Addendum 1

Date: Friday, March 5, 2021

Project No: HDG - 201-204

Project Title : Peekskill City School District

Existing First Floor Hazardous Materials Plan

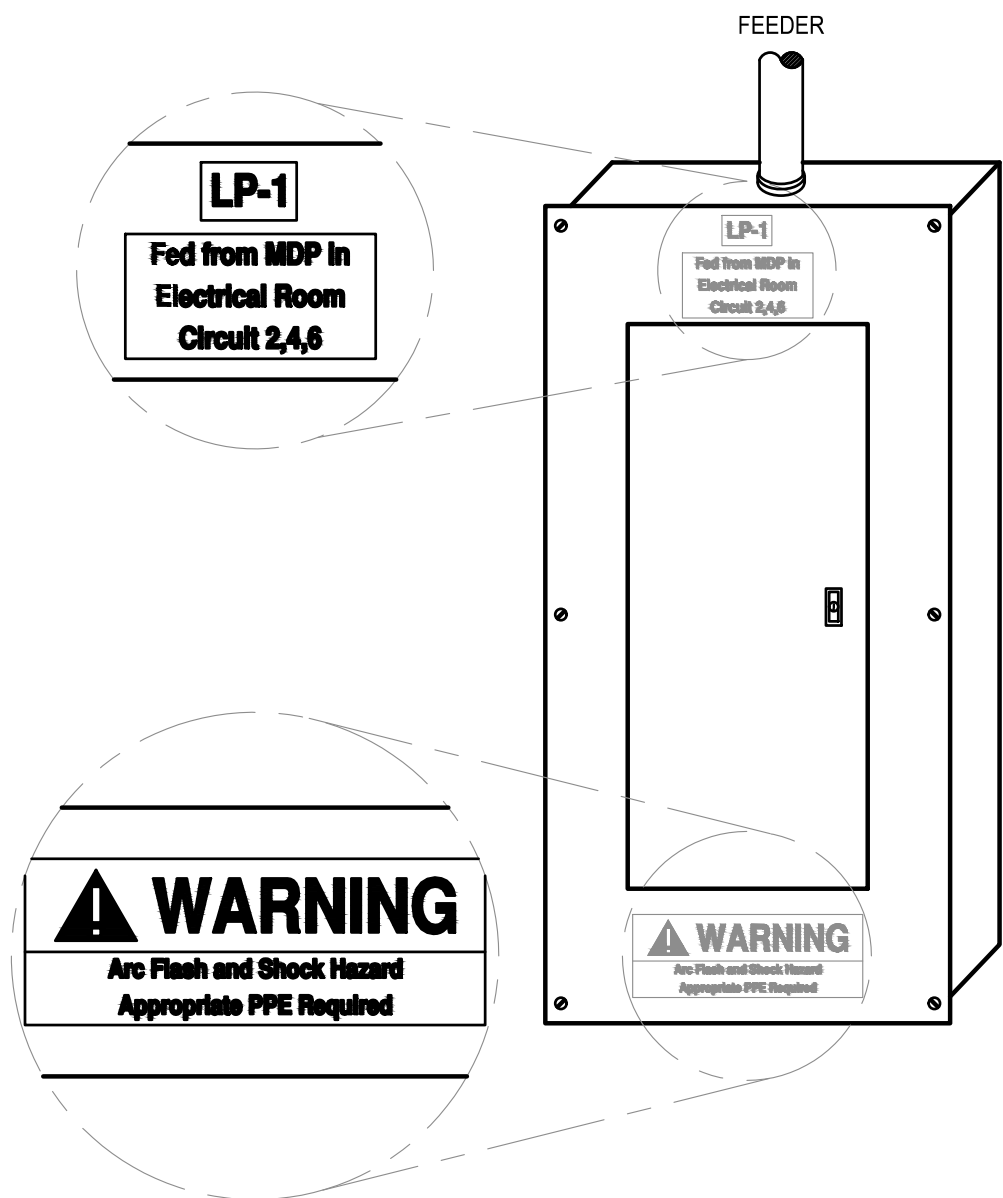
- c. *The abatement contractor shall remove built-up roofing in the area of the new roof mounted exhaust fan. Coordinate work with the mechanical contractor. Area location is indicated on drawing W-H.102.00 to provide the approximate location of the removal. The contractor is responsible for verifying the amount and location of material.*
 – ADDENDUM I
